CORRO-CONSULTA

MEMORANDUM

Subject: Update of Current Knowledge Regarding the State of Integrity of OCNGS Drywell Liner and Comments Pertaining to Aging Management Thereof

Figure 2

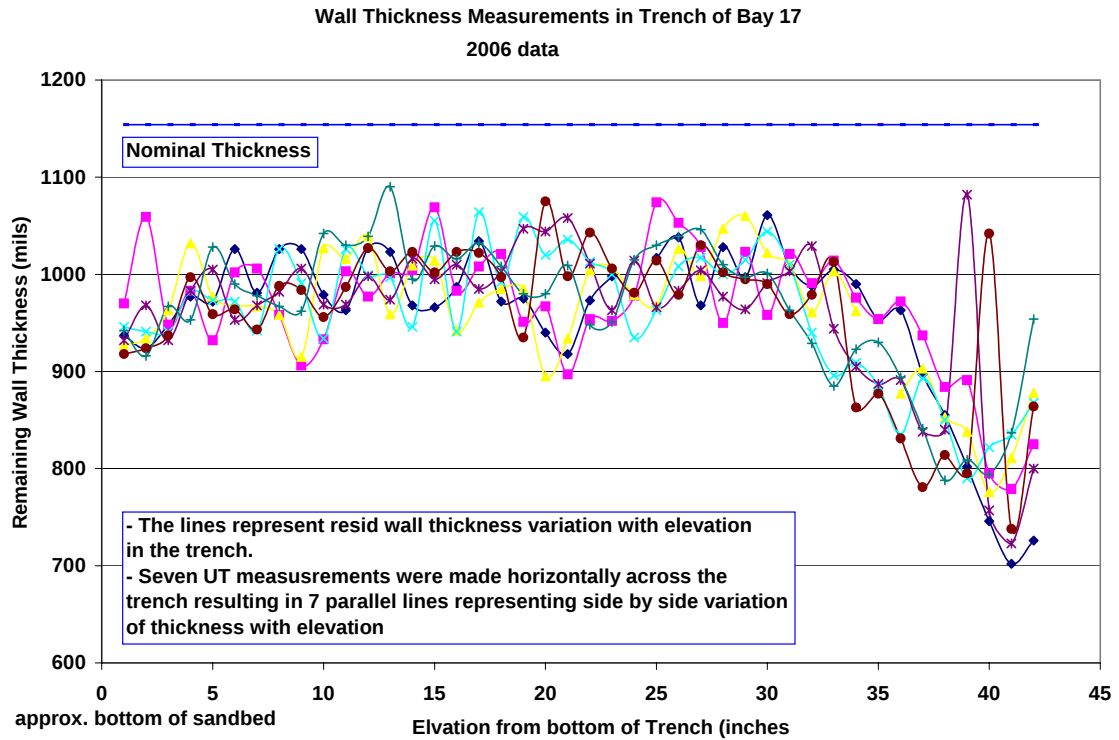
We take issue with this statement. In support of this contention, an effort was made to show graphically the remaining wall thickness observed in all of these various locations. Thus Figure 2 shows, by way of example, the remaining wall thickness from the 2006 UT measurements made with the help of 6 by 6 inch grids as a function of elevation in the **trench of Bay 17**. It is understood, as is described in Ref. 3 that 6 such grids were placed one on top of the other in the trench in order to capture the corrosion from the bottom to the top of the sandbed. Hence, if the bottom of the trench had the elevation about 9 feet, then the top of the 6 grids would have had an elevation of about 12 feet, which according to Figure 1 corresponds to the top of

the sandbed and is at least 9 inches higher than the top of the grid used for UT measurements from the inside. (Note, none of these elevations is terribly accurate, however, the top of the trench measurements were definitely lower (deeper pits) by a good margin than the inside grid measurements). Figure 2 plots all individual 2006 measurements from the trench in bay 17. The 6 traces represent the variation of the wall thickness in the horizontal direction while the traces themselves extend from the bottom of the trench (left hand side) to the top of the trench (right hand side). The undulations of the 6 traces, which are at times (at the same elevation) in synch and at other times out of phase clearly depict the nature of the “golf ball type” surface described in AmerGen literature (Ref. 1 pg. 4). Where the undulations are in synch one can estimate that the extent of the pit at that location extends over an area larger than just one inch in diameter ³⁾. It should also be noted that the average amplitude of the undulations in Fig. 2 are of the order of 0.1 inch, i.e. the roughness of the surface at this point is only of that order of magnitude. AmerGen estimated the “roughness” of the surface to be rather of the order of 0.2 inches (Ref. 5 pg. 5).

The most striking observation is that the corrosion is most severe at the top, almost uniform in severity over most of the depth of the sandbed and again somewhat more severe at the very bottom. **In other words, one sees already in this presentation that it would be difficult to single out one small area by means of a 6 by 6 inch grid and claim it to be representative of the corrosion having occurred in the sandbed area.**

Figure 3

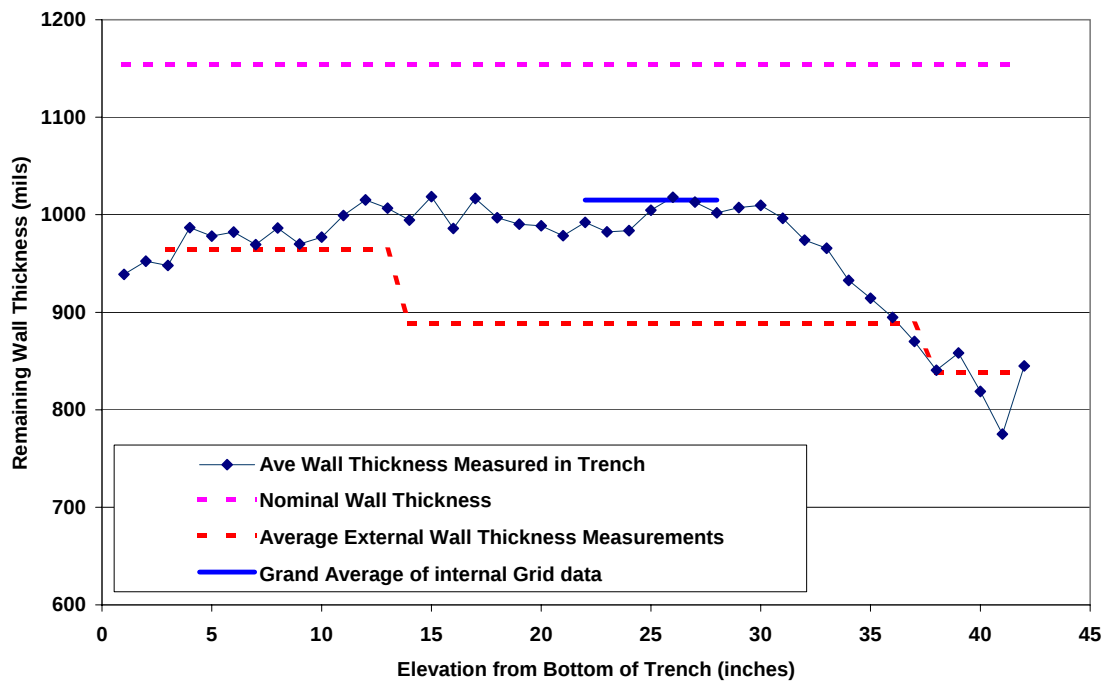
In Figure 3 an effort is being made to compare the average remaining wall thickness from trench measurements (averaged over the horizontal direction) with the average of the 6 by 6 grid measurement from the inside and the direct UT measurements from the outside. Also graphed in this figure are the averages of the outside measurements for the three zones for which data are reported (Ref. 5). What one can see is that the averages for the grid and the trench data overlap quite well at the same elevation. However, the average outside measurements are significantly lower at comparable elevations. ⁴⁾ This is probably because the choice of location for the external measurements was deliberately biased towards thin spots.

Figure 4

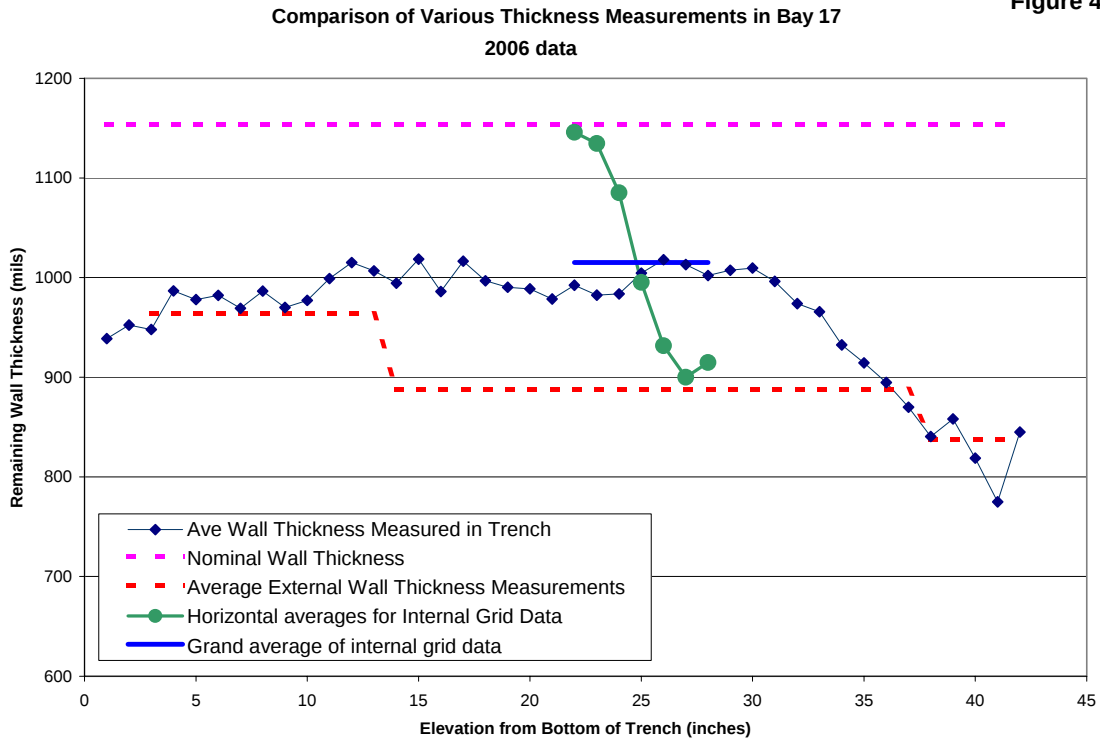
Finally in Figure 4 we see the spread of the 6 by 6 inch inside grid measurements superimposed on the averages of the other measurements.

Conclusion: What the superposition of the UT measurements in Bay 17 demonstrates is that wall loss ranges from zero to 33 percent, however, only the trench and outside measurements come close to represent the most severe corrosion at the highest elevations. The inside grid measurements give a distorted picture. It should also be remembered that the grid measurements at the inside curb cutout as well as those in the trench are only 6 inches wide. One

Figure 5

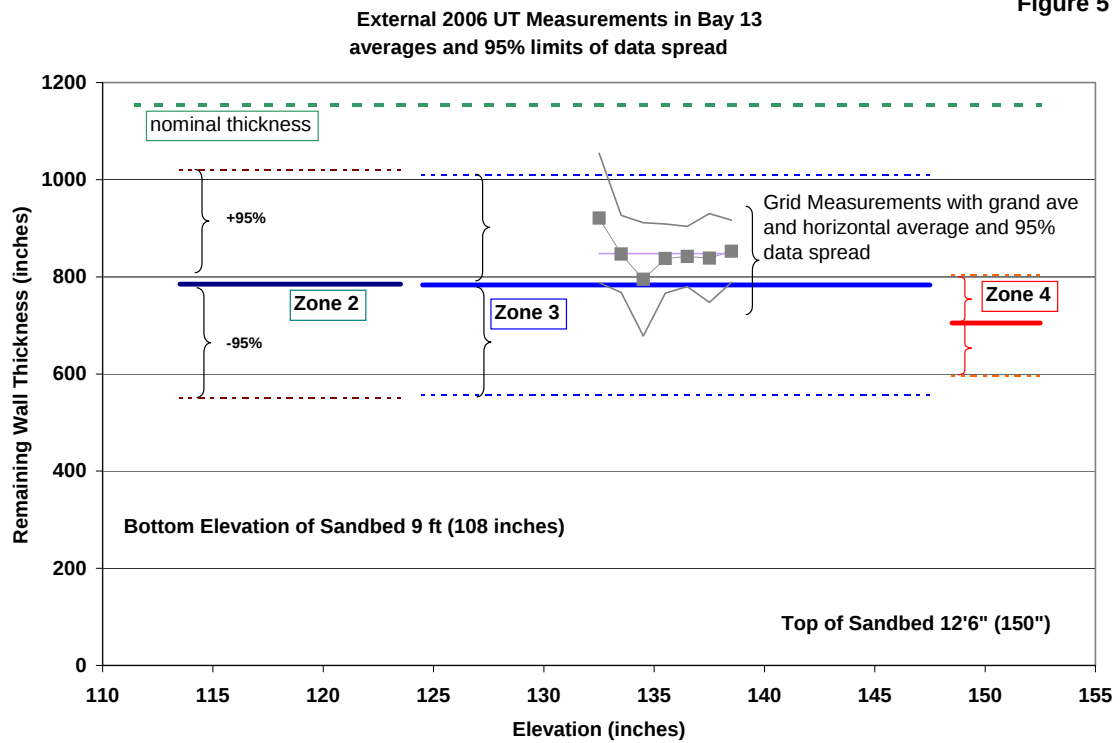
Figure 5 shows an analysis of the available 2006 data for Bay 13. Bay 13 is probably the second worst corroded bay apart from Bay 1. The averages for the external measurements for each zone are fairly similar, as are the 95% limits for the data spread. There is a 95% percent probability for the deepest penetration to be of the order of 48% of the original wall thickness. The superposition of the internal grid data shows a higher average and a narrower distribution of the data spread. Again one recognizes that the internal 6 by 6 inch grid measurements do not represent the worst corrosion degradation.

Figure 6

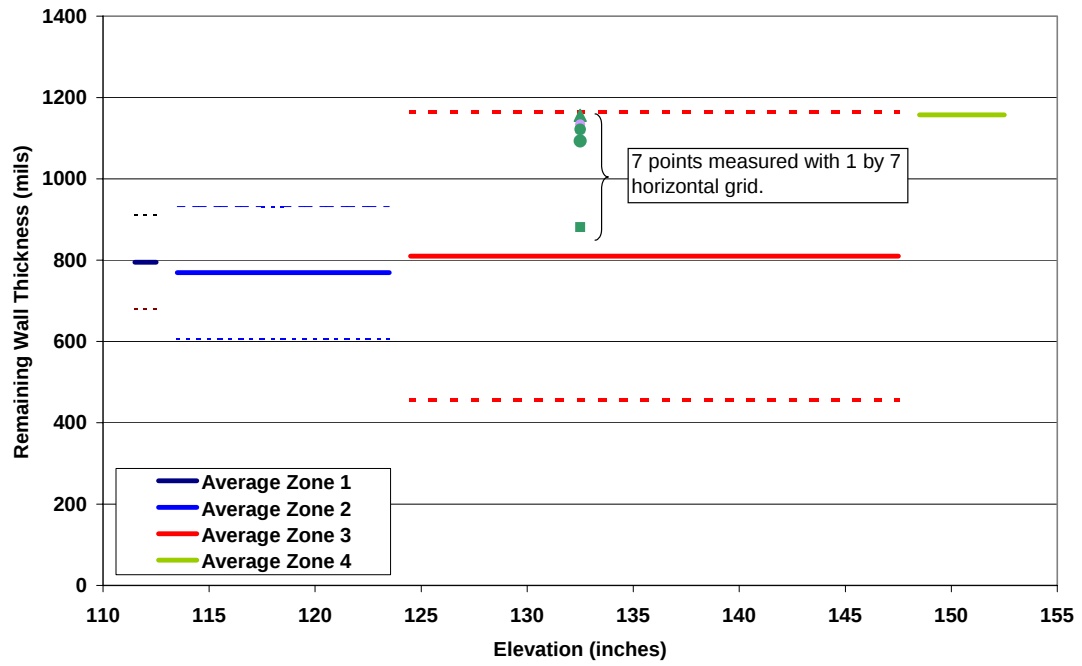
Finally in Figure 6 we show the distribution of the external measurements for Bay 1. One observes that the 95% lower limit of the data spread is around 40% of the original wall thickness, or indeed at a remaining wall thickness of 450 mils, which is 0.04 inches below the required sandbed thickness for the Design Pressure and Temperature. Because the external sampling in Bay 1 was designed to capture the thinnest points, this is a conservative estimate of the minimum wall thickness. However, given the need for a very high degree of confidence that the drywell shell is ready to withstand accident pressures and the uncertainty created by the sparse data set, I believe that a conservative approach is required in this case.

Figure 7

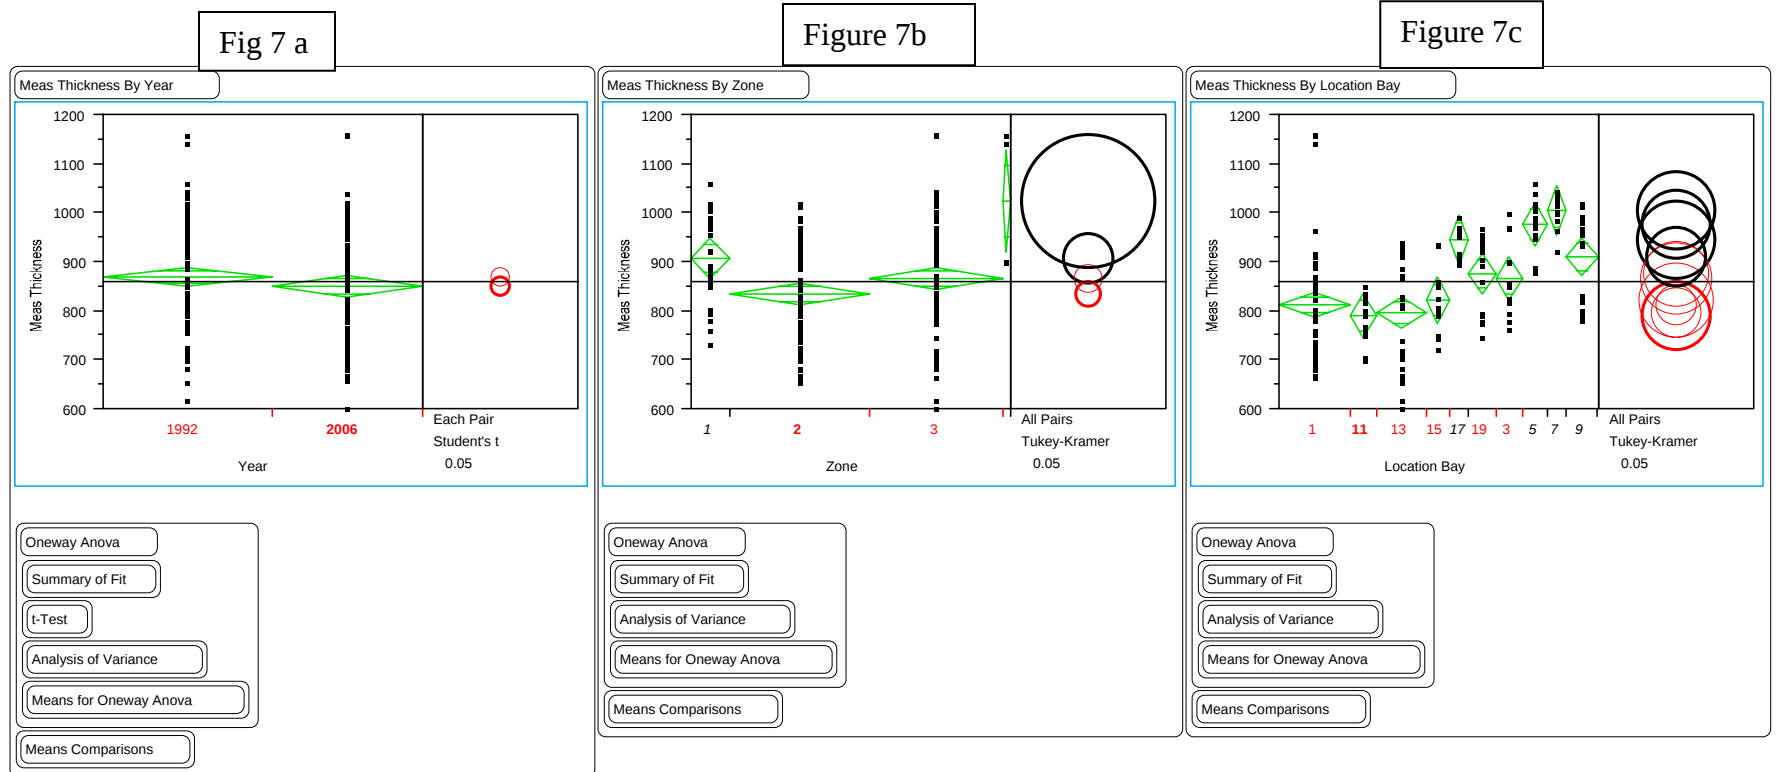
It was found that there is no significant effect of the time (Fig.7a). While there is a decrease of 19 mils between 1992 and 2006, this difference is not statistically

significant within the variability of the data. The differences between the zones, however are significant. Zone 2 is by far the most corrosive zone. When the bays are compared, one finds as expected that some bays have experienced little corrosion in contrast to others. The importance of these observations is obvious: they point again to the fact that the intensity of corrosion is a clear function of elevation and bay. Hence, averaging data and generalization may lead to doubtful conclusions.

Figure 7a: Comparison between measurements I 1992 and 2006 show no significant difference. The means from 1992 and 2006 show a bias of 0.018 inches, but the bias is statistically not significant despite of the many data points. Fig. 7b: The comparison between the “zones” (elevations) is significant. Zones 1 is significantly different from zones 2 and 3. For zone 4 there are not enough data for statistical significance. Fig. 7c: Some bays, red ones, are significantly different from the black ones.

Figure 8: External UT Measurements in Bay 15

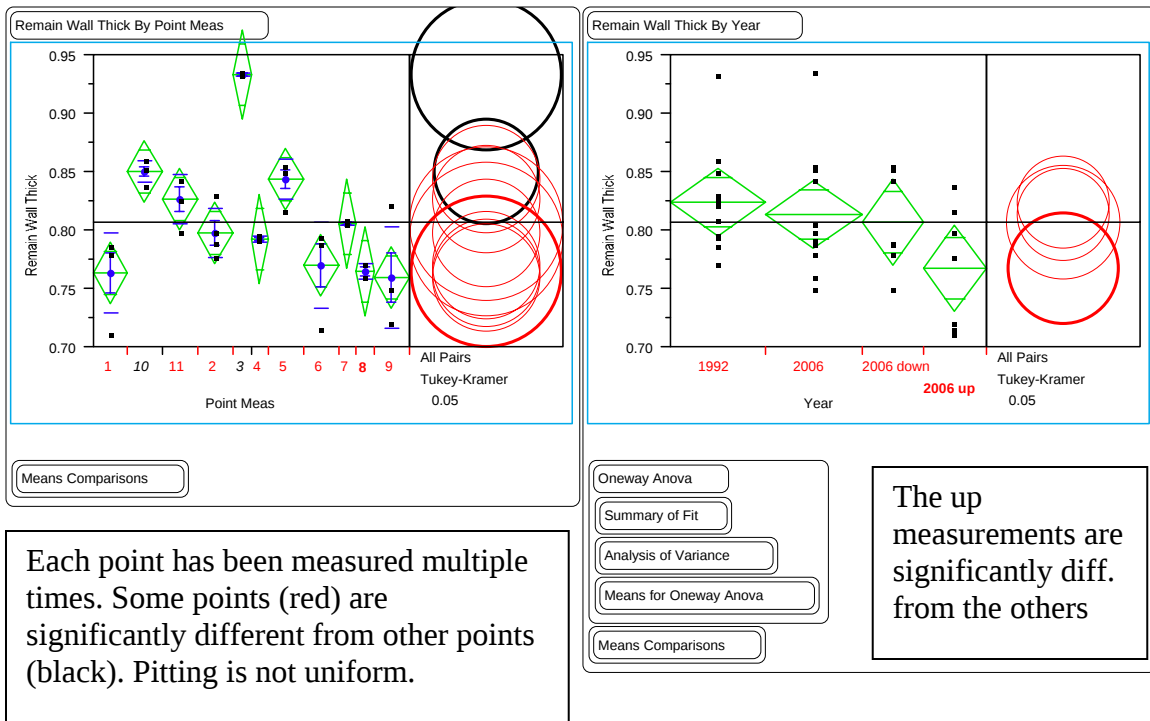
In 2006 the validity of some of the external UT measurements was explored by measuring around the nominal original locations. These data were statistically evaluated in Figures 8, 9, 10 for Bays 15, 1 and Bay 19. The additional data collected in Bays 19 and 15 had been identified as “up” or “down”, hence additional data sets identified as 2006 up and 2006 down were compared with the original 2006 data. It turns out for Bay 19 for instance that the UT penetrations identified as 2006 up were significantly lower than the measurements of 1992 with a probability of better than 95%. The difference between the 1992 and 2006 up data is 0.1 inch. Similarly for Bay 15 one finds that the 2006 up data are significantly lower than the original 1992 data by about 0.06 inches, although this difference is not significant at the 5% level. For Bay 1 there is practically no difference between the 2006 and the 1992 data sets, because of the two or three measurements in the non-corroded areas. Summarizing these results in Table 1, one finds that the lower 95% confidence limits for Bays 1, 15 are marginally within the 0.736-inch limit. Since one does not know exactly how extensive the “cancer of corrosion” in the sand bed area really is, it is very difficult to put this interpretation in perspective with the assessments made by AmerGen relative to areal criteria for thinned areas (see discussion below).

Figure 10: External UT measurements in Bay 19

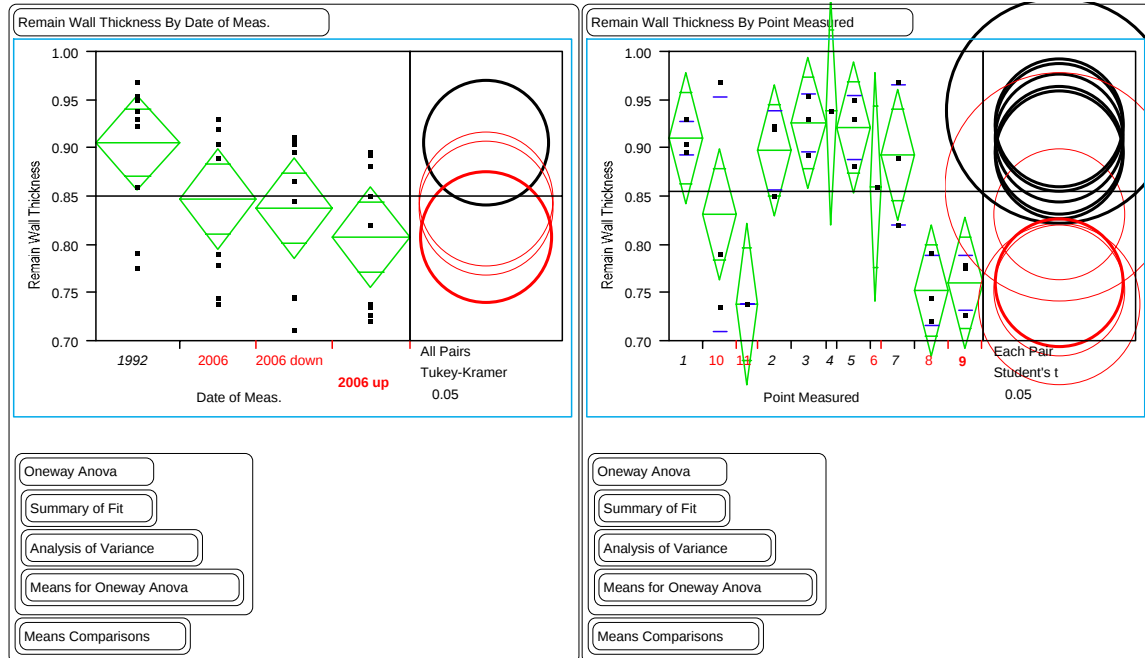
Again one finds that the “up” measurements are significantly lower from the 1992 measurements.
